Access Compliance Report Public Rights-of-Way (Curb Ramps)

Main Street: CORONEL_RD		Cross Street: THORLEY_RD		Location:	NE
ADA ID: RPRK211013120656	Ramp Type: Type 4 - Parallel	Initial Pass/Fail: Fail	Overall Compliance: No	Severity Score:	15

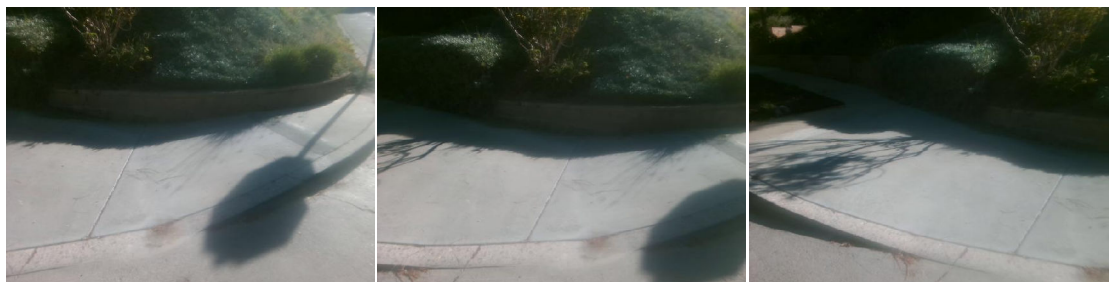
Compliance	Description	Data	Compliance	Description	Data
N/A	Ramp Length LT (in)	130	N/A	Ramp Length RT (in)	100
Yes	Ramp Width LT (in)	114	Yes	Ramp Width RT (in)	76
No	Ramp Run Slope LT (%)	11.3	Yes	Ramp Run Slope RT (%)	8
Yes	Ramp Cross Slope LT (%)	1	Yes	Ramp Cross Slope RT (%)	0.9
N/A	Landing Present	N/A	N/A	DWS Provided	N/A
N/A	Landing Length (in)	N/A	N/A	DWS Contrast	N/A
N/A	Landing Width (in)	N/A	N/A	DWS Length (in)	N/A
N/A	Landing Run Slope (%)	N/A	N/A	DWS Full Width	N/A
N/A	Landing Cross Slope (%)	N/A		DWS Offset Type	N/A
N/A	Landing Movement Obstructed?	N/A	N/A	DWS Offset Left (in)	N/A
	Landing Movement Type	N/A	N/A	DWS Offset Right (in)	N/A
N/A	Landing Shared	N/A			
N/A	Clear Space	Yes			
N/A	Clear Space To Crosswalk (in)	N/A			
N/A	Marked Crosswalk 1	No	N/A	Marked Crosswalk 2	No
	Crossing 1 Direction	NW		Crossing 2 Direction	SW
	Marked Crosswalk 1 Width (in)	N/A		Marked Crosswalk 2 Width (in)	N/A

Remove & Replace Curb Ramp With Two New Directional Ramps or Equivalent.
